MAYOR & COUNCIL COMMUNICATION

AGENDA ITEM: Halcyon Cemetery Preliminary and Final Plat

PLANNING COMMISSION
DATE: 7/13/2015
AGENDA ITEM: 4A – PUBLIC HEARING
CASE # 2015-06

EXISTING CONDITIONS & REMOVALS

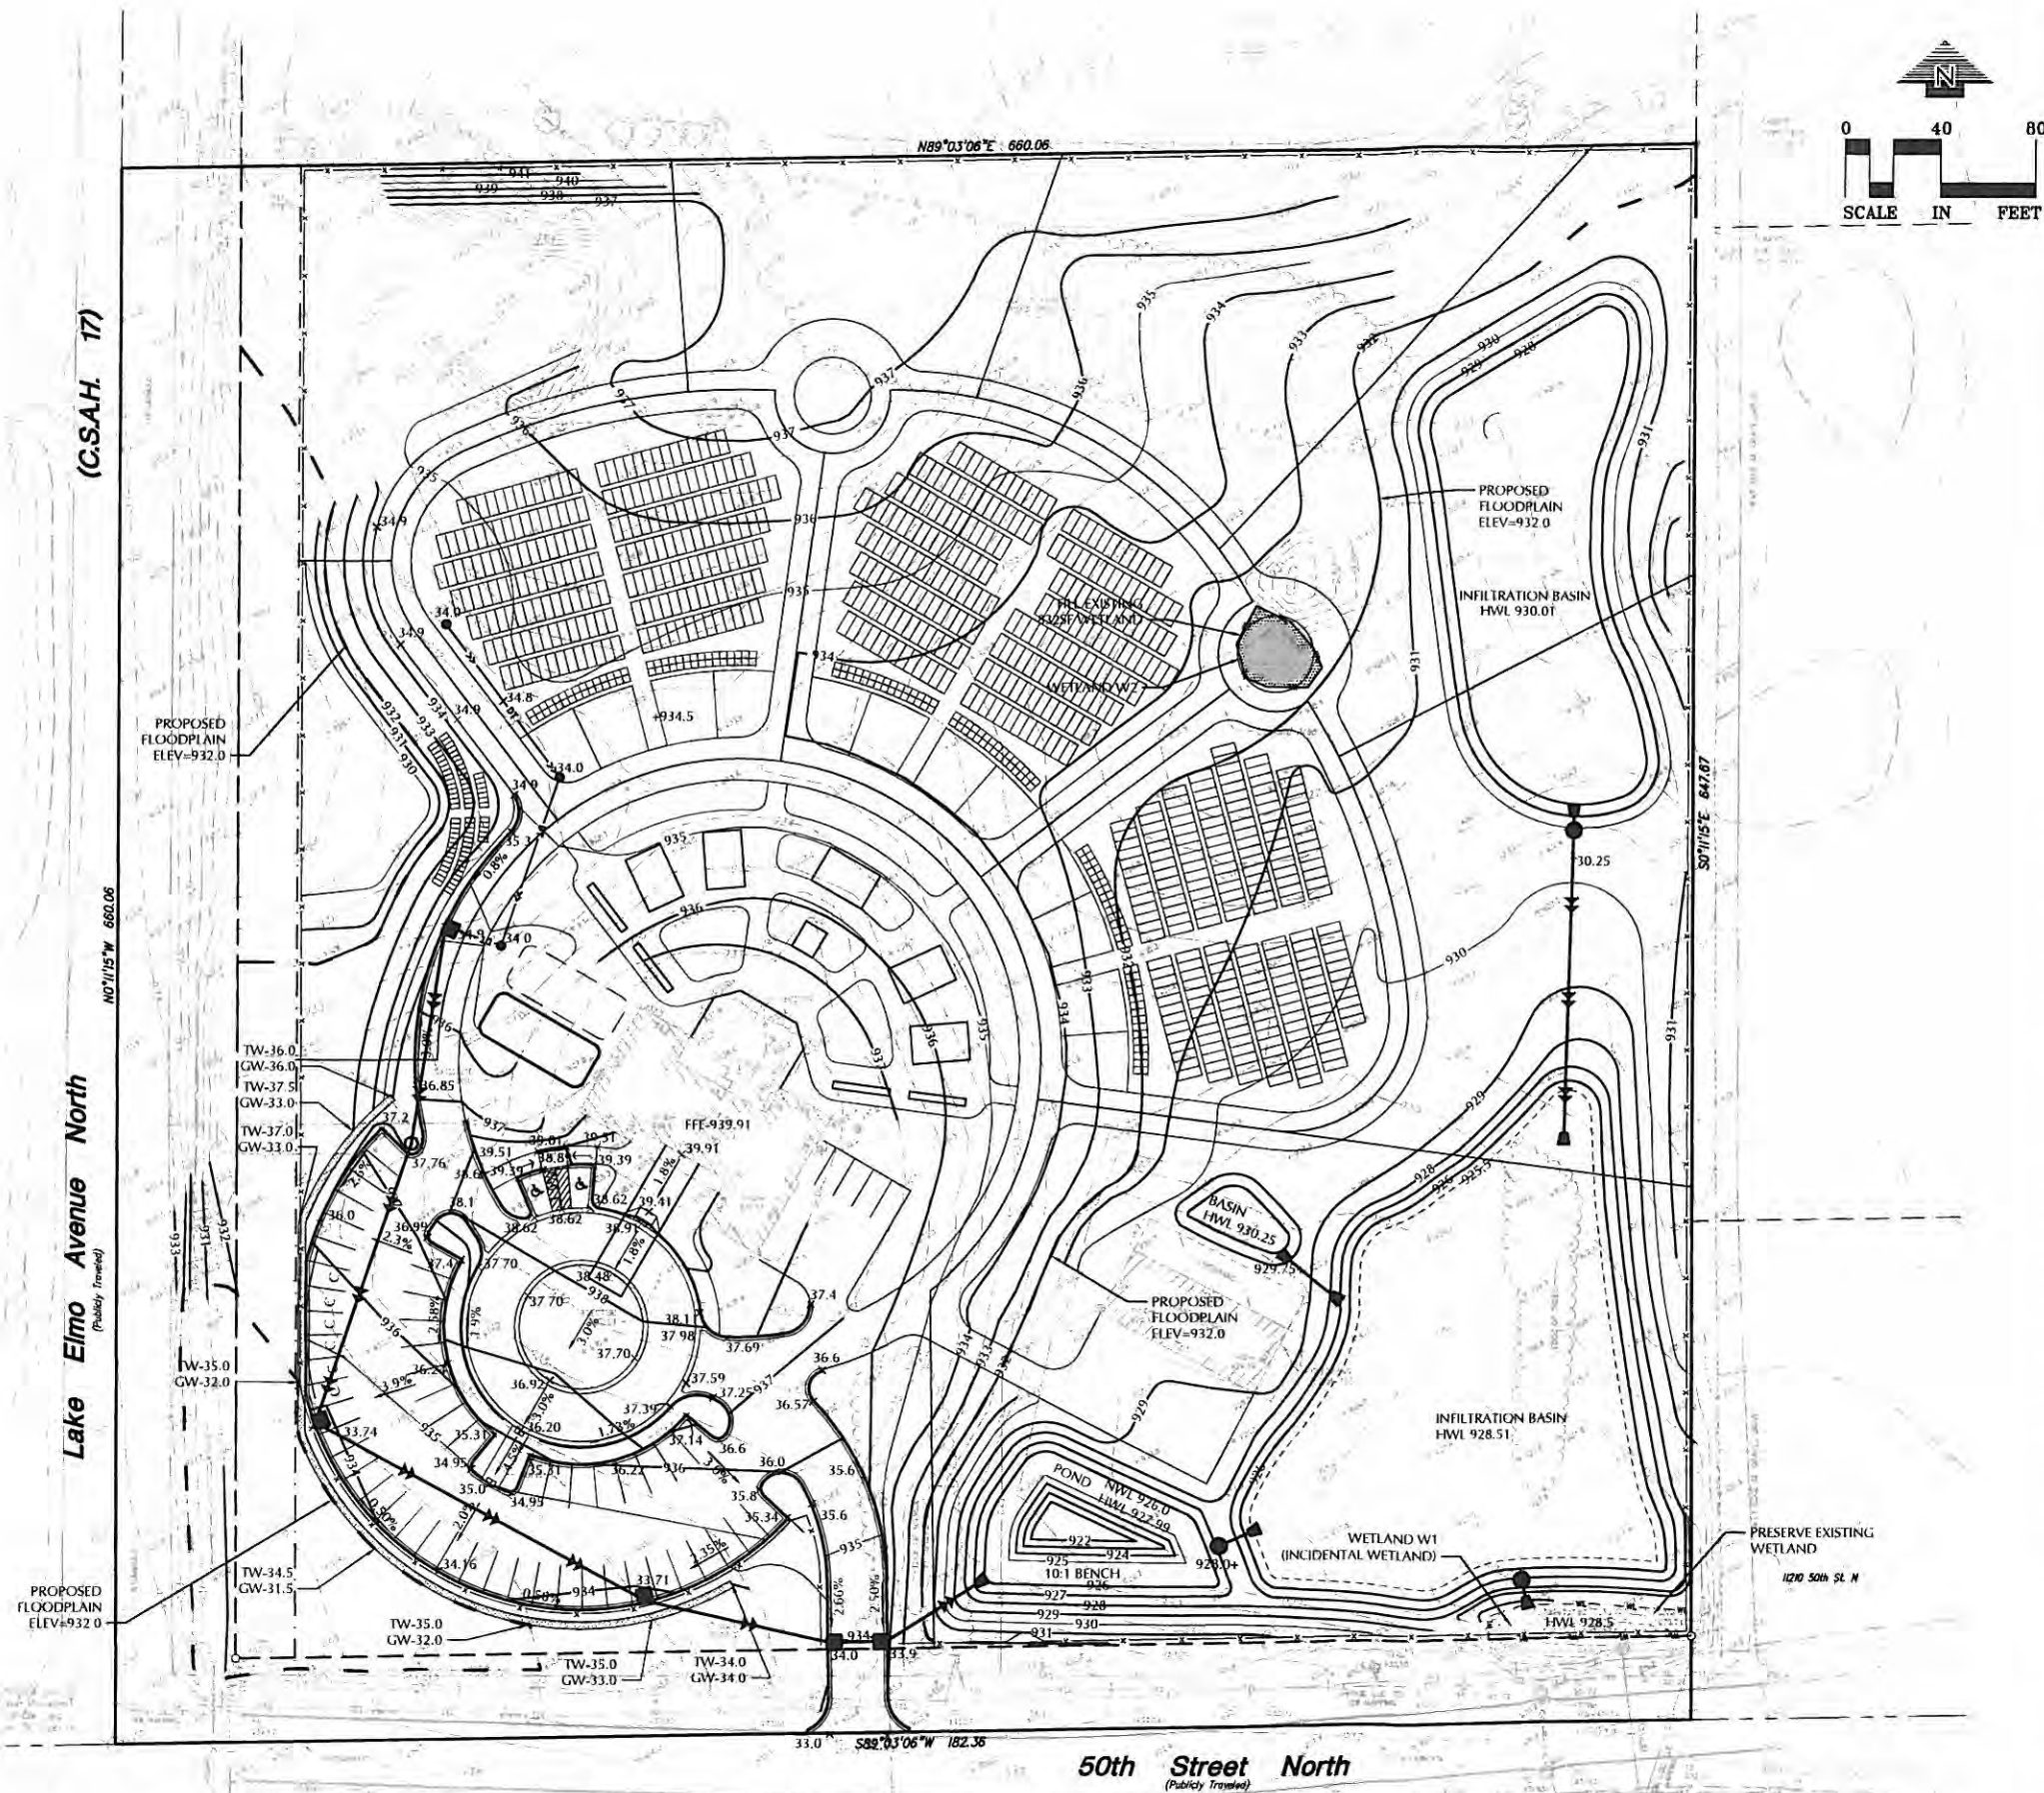
- The Tree Protection detail on Sheet C1-1 and Sheet L1-0 must be replaced with the City standard detail 904.

GRADING & DRAINAGE
PLAN

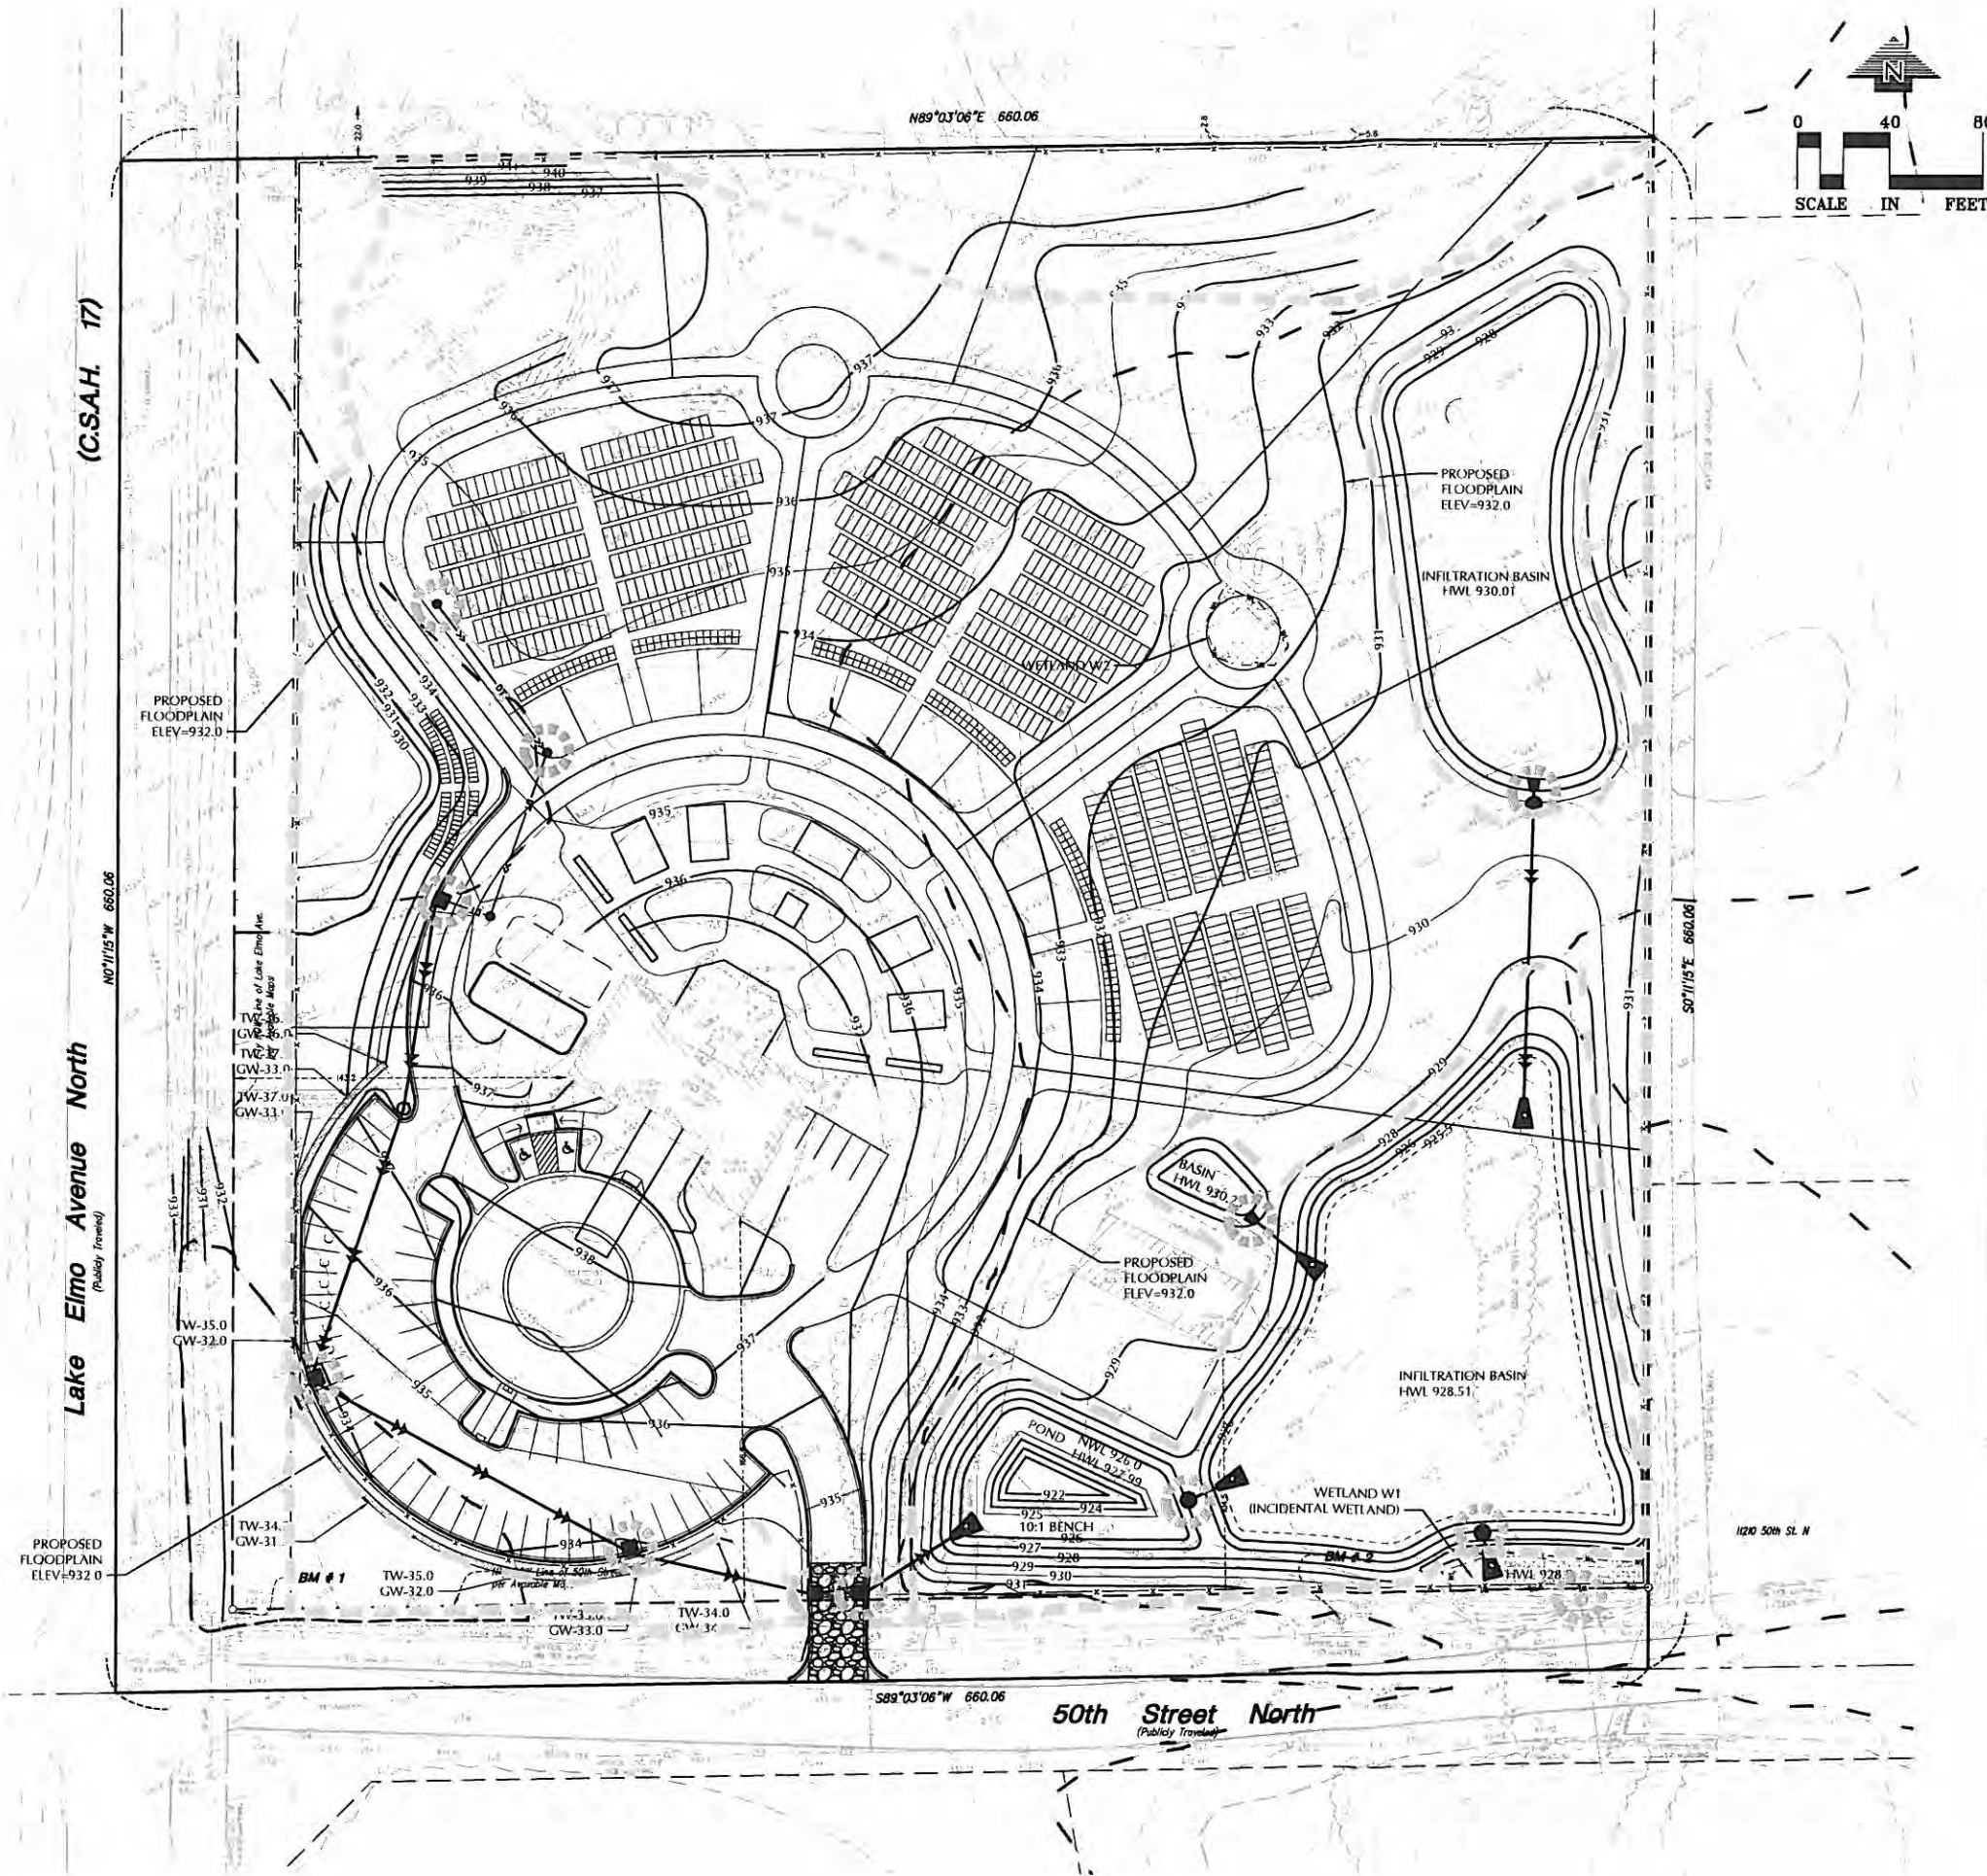
- Provide plan notes on Sheet C3-1, C3-2 and C4-1 calling out measures to protect both the existing and proposed drainfield sites throughout the construction process.

EROSION CONTROL PLAN

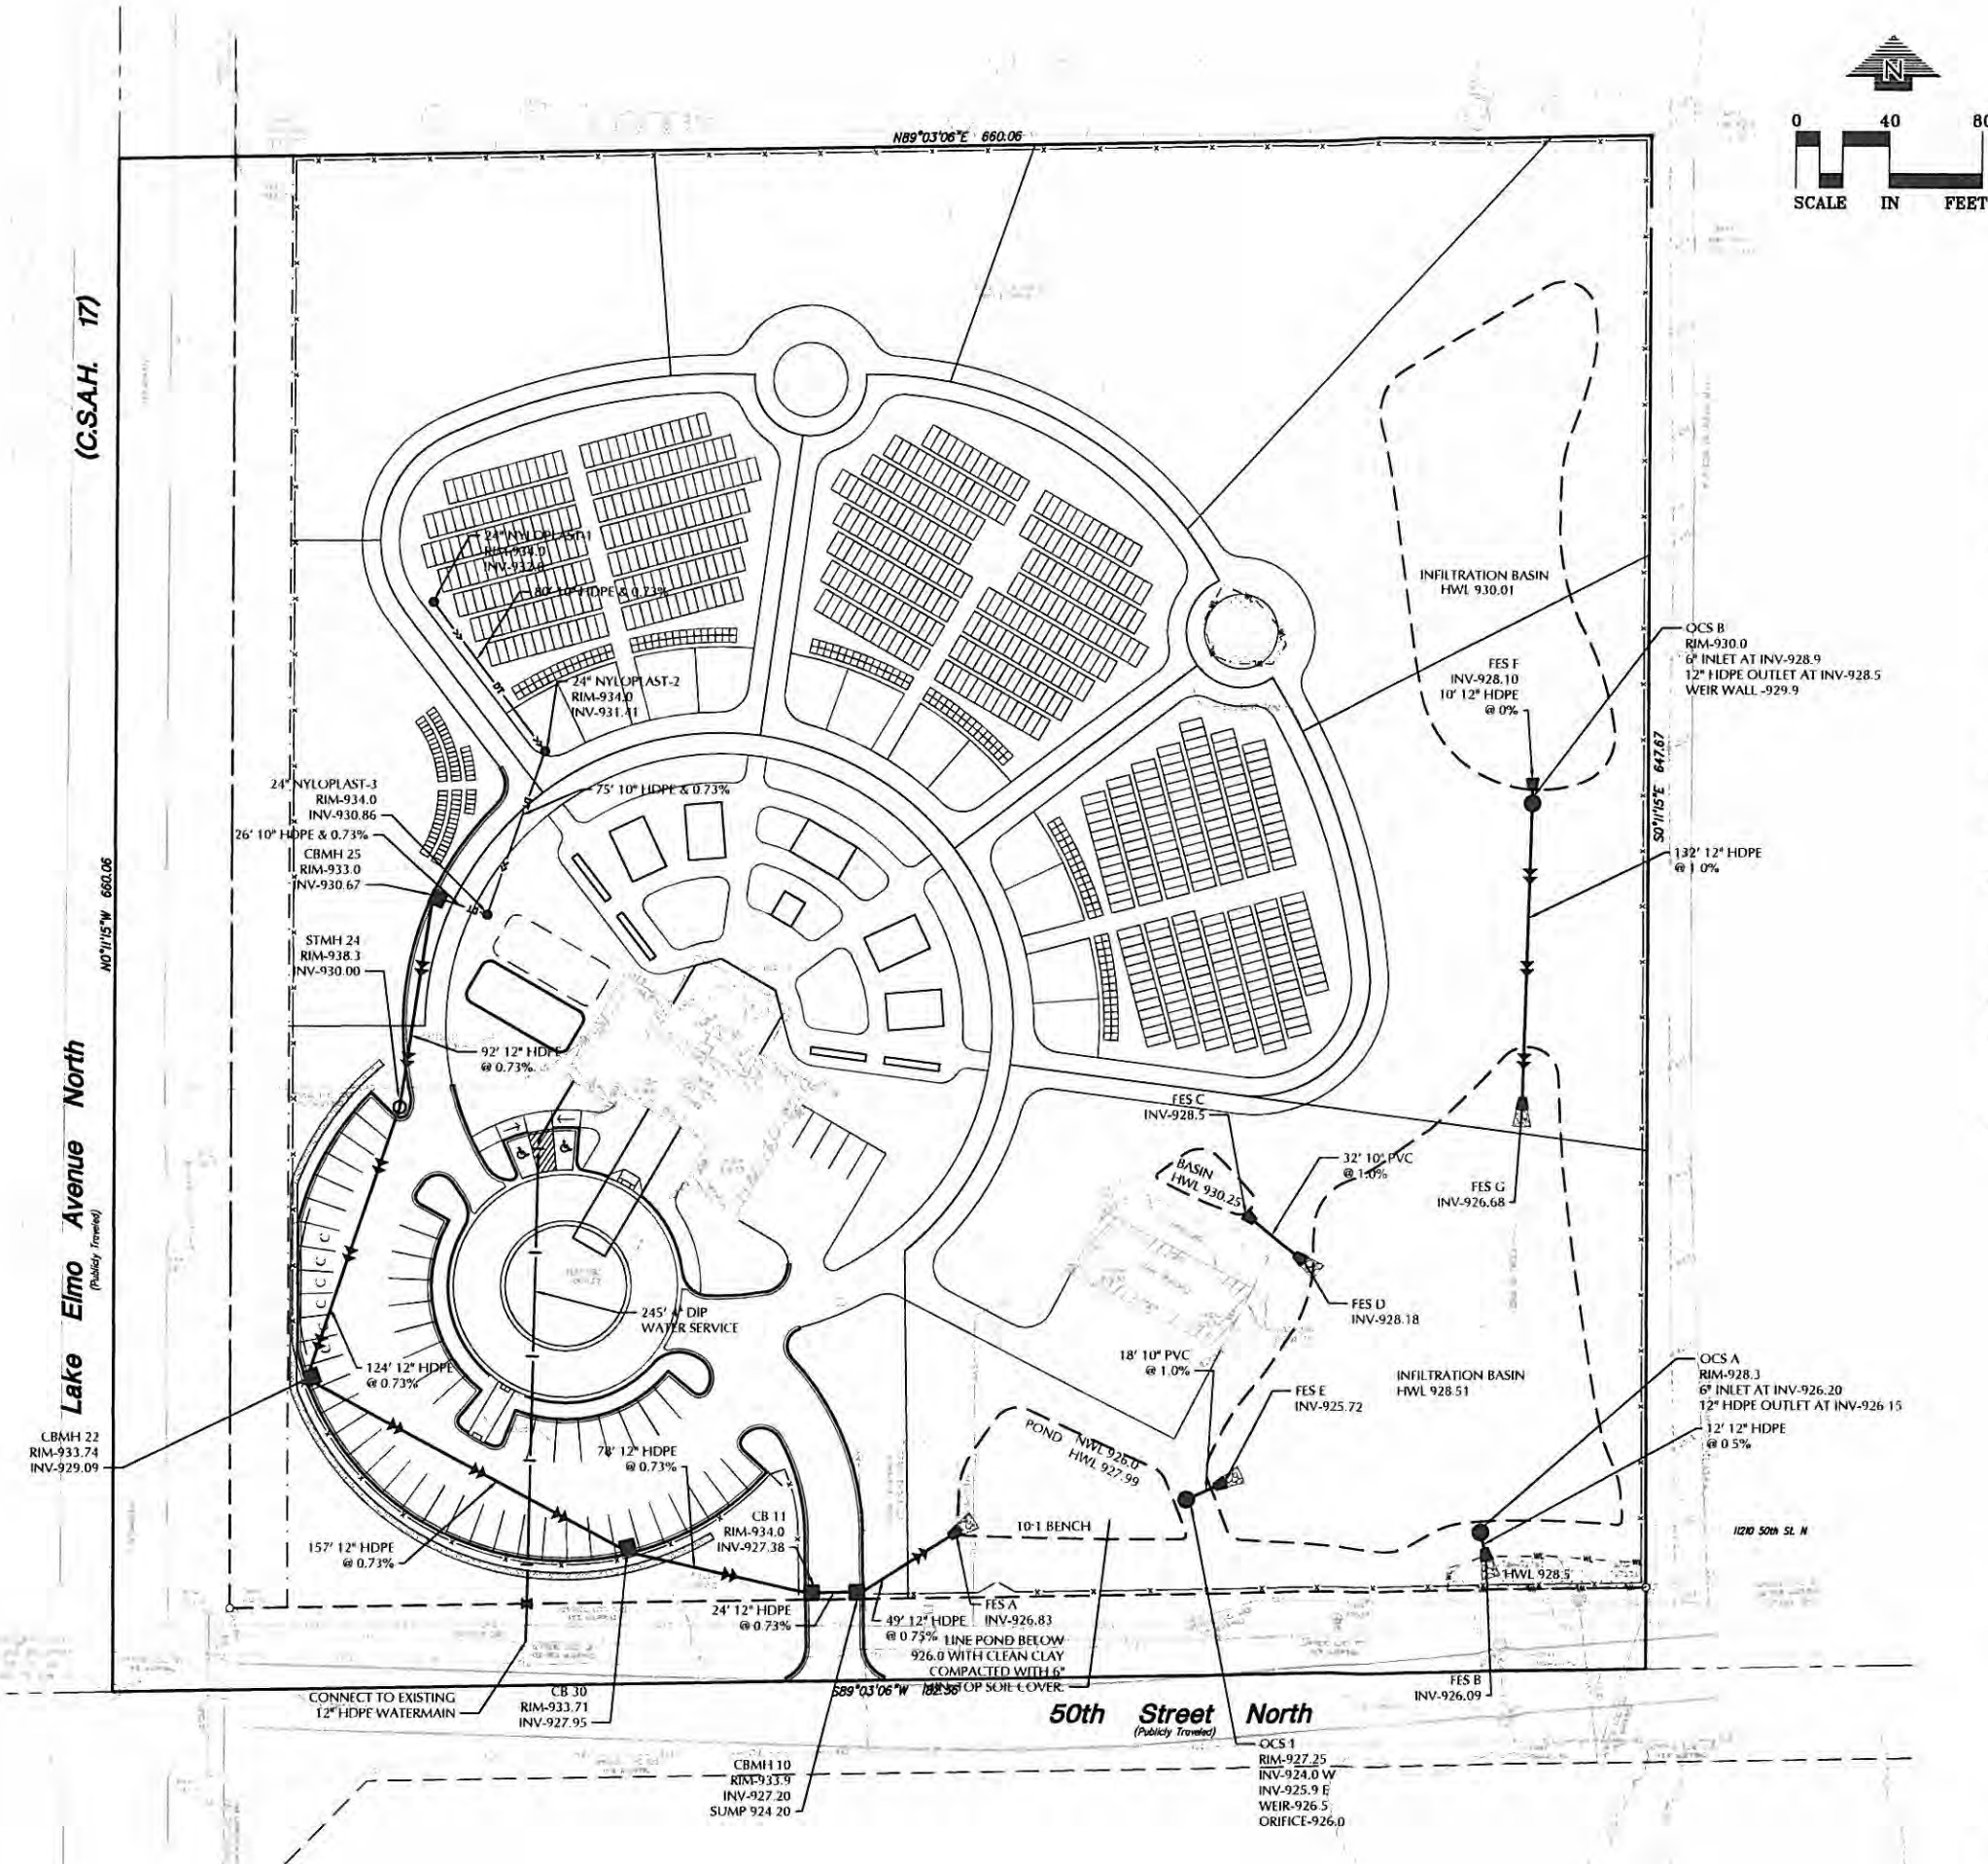
Item 17. Phasing plan. As discussed the phase 1 and phase 2 areas on the erosion control plan will be clearly identified.
